TECH NOTE

HONDA ACCORD/LEGEND/MDX TIMING COVER MODIFICATION REQUIRED WITH REPLACEMENT OF BELT TENSIONER

BULLETIN: TSB005_AU

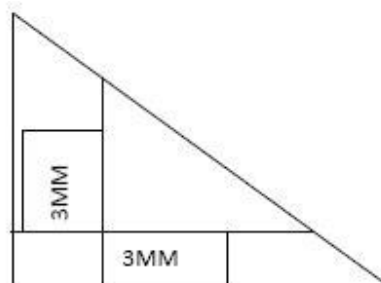
Honda OE now provides an updated tensioner assembly which may cause interference with the front timing cover for some applications. Gates also offers the same updated design as the OE. The update requires that you now remove approximately 3mm of plastic material from the front cover, allowing proper clearance.

Improper clearance may result in a damaged front timing belt cover.

THIS AREA WILL NEED TO HAVE 3MM OF MATERIAL REMOVED

The removal of approximately 3mm of plastic material from the lower timing belt cover is recommended prior to the installation of the updated accessory belt drive tensioner, allowing for proper clearance.
